# Change Order Request

**Project:** 1923025-02  
La Crosse Center Expansion & Renovation  
400 La Crosse Street  
La Crosse, WI 54601

**COR #** 7.00

**PCO #** 18 - Duct Bank Excavation

**2S1-21**

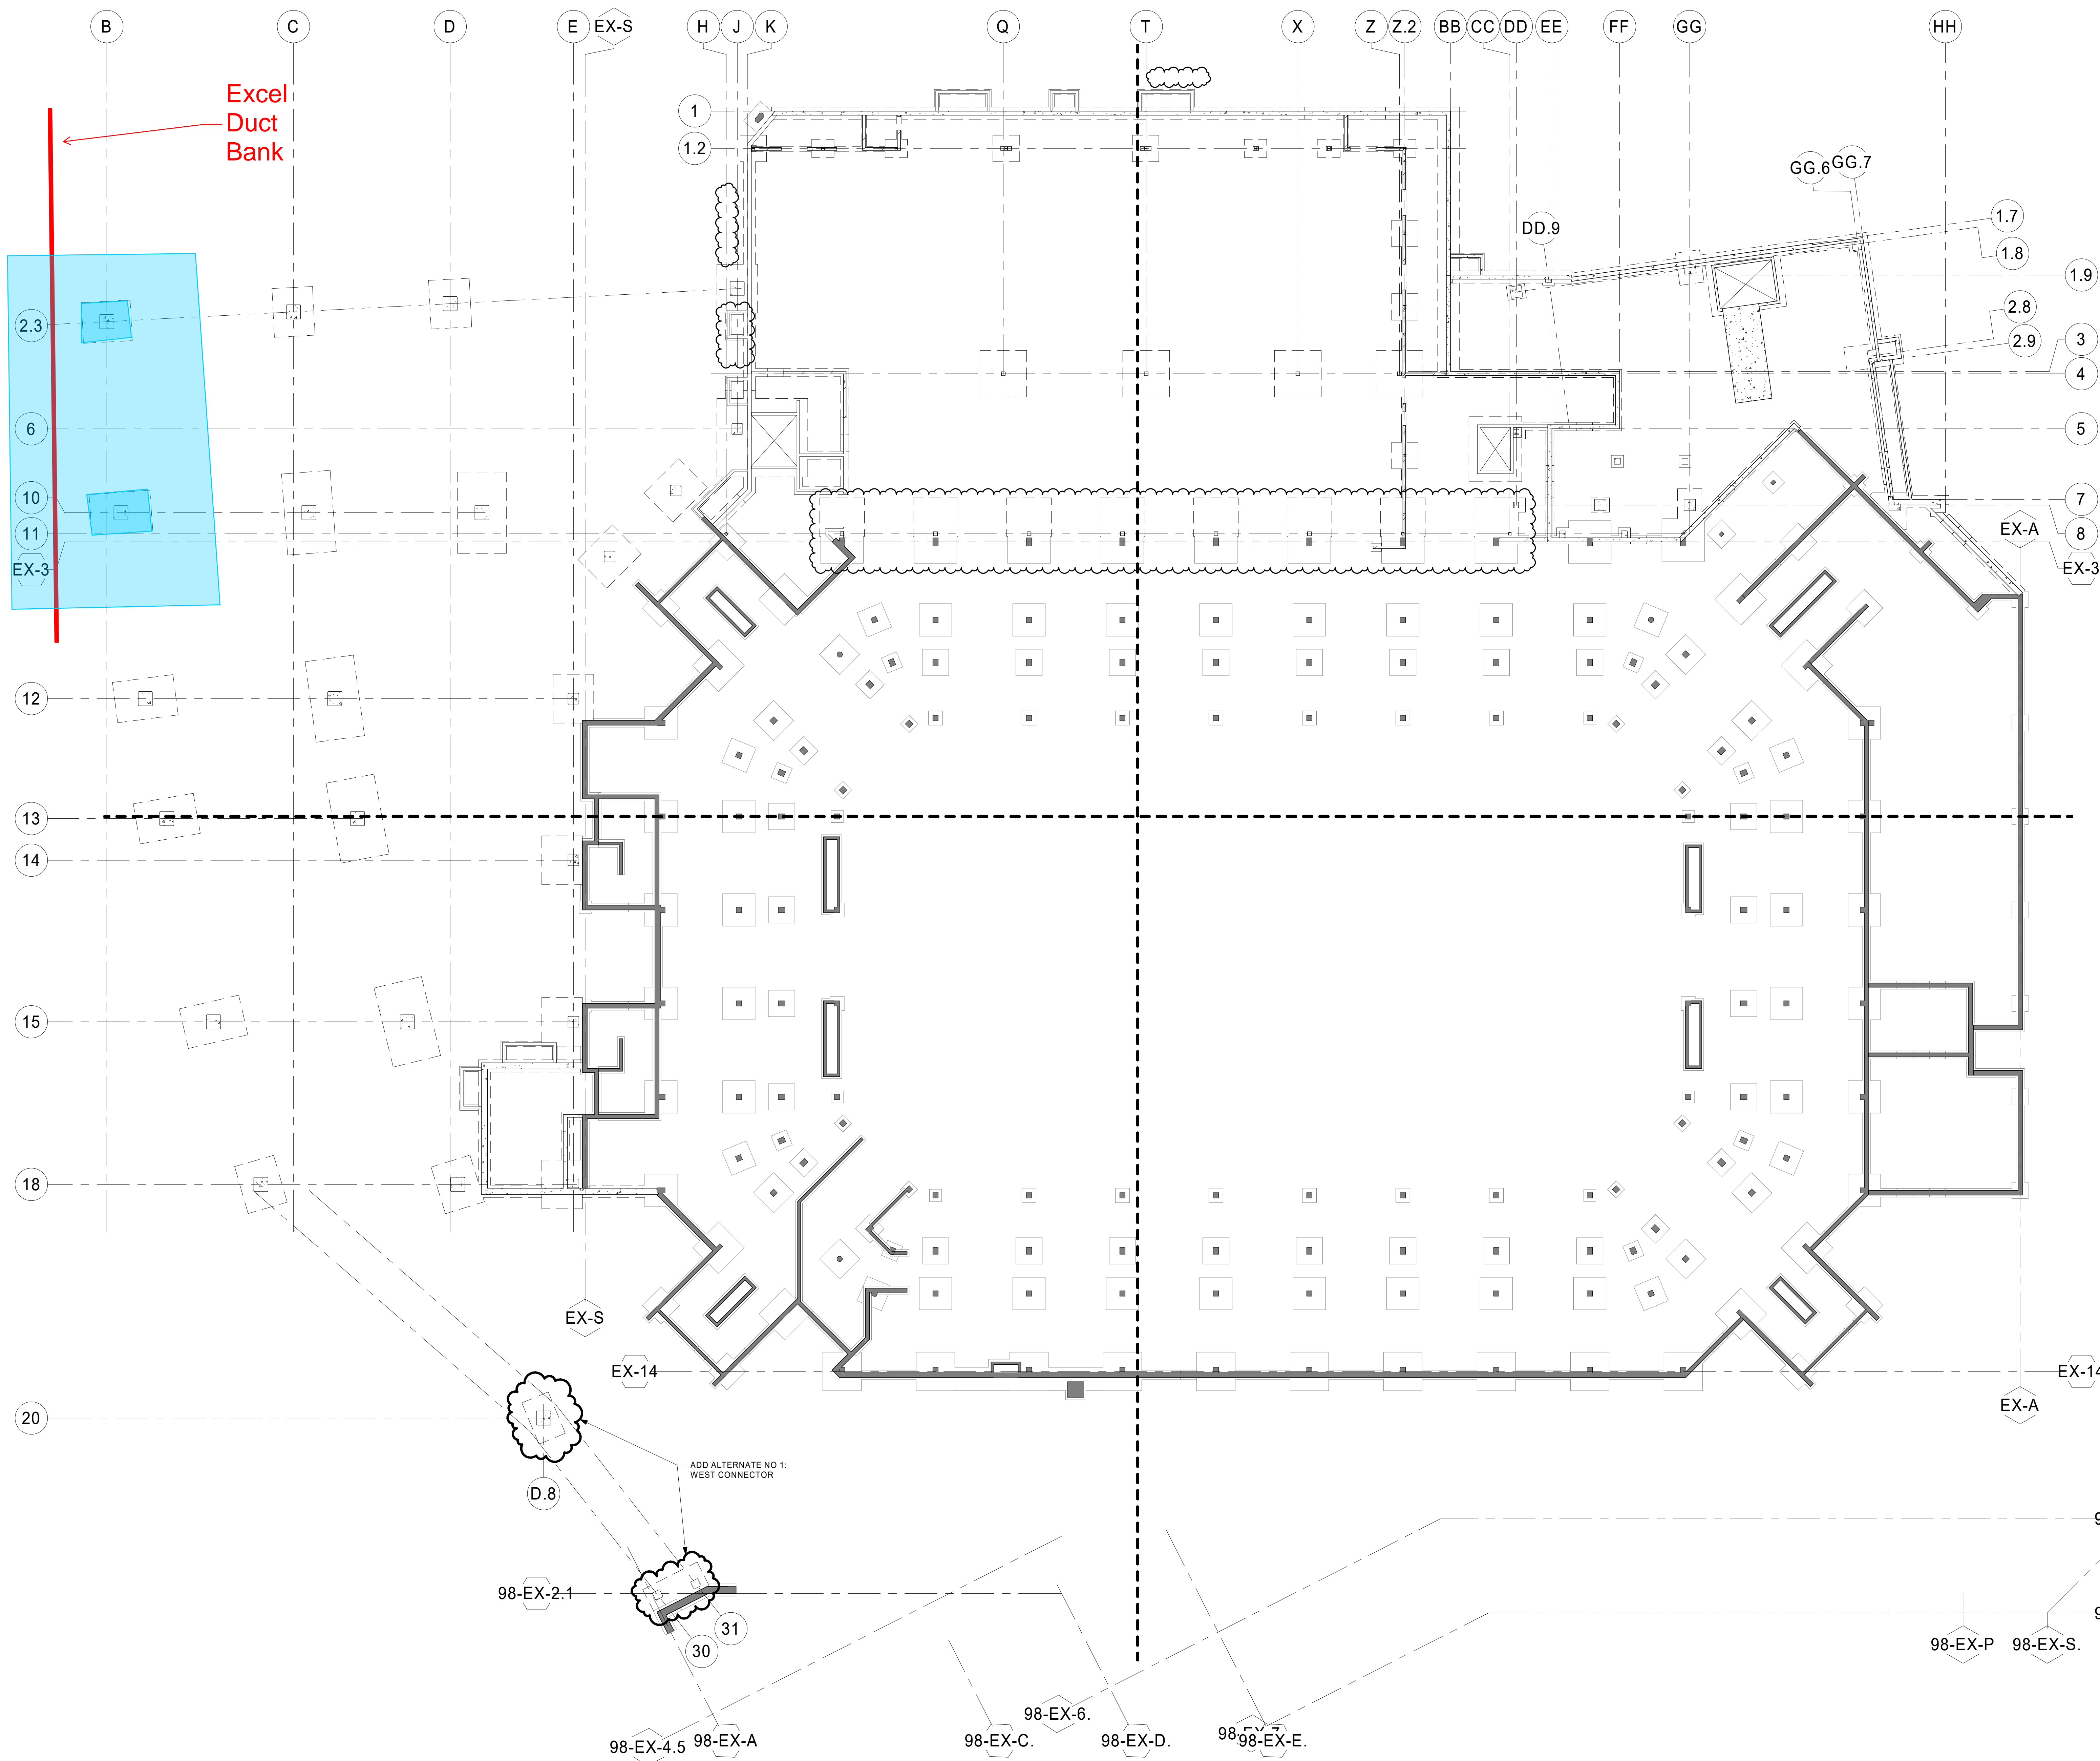
Unsuitable soils were identified under the attached highlighted ballroom footings, to a depth of approximately 12' below bottom of footings. Due to the depth of the excavation to remove and replace the unsuitable soils we will undermine the duct bank. Undermining the duct bank will cause it to crack and compromise the conductor inside. The duct bank is a \$1M piece of infrastructure for Xcel.

Attached is the cost to install earth retention to support the duct bank while the contractor removes and replaces the unsuitable soils.
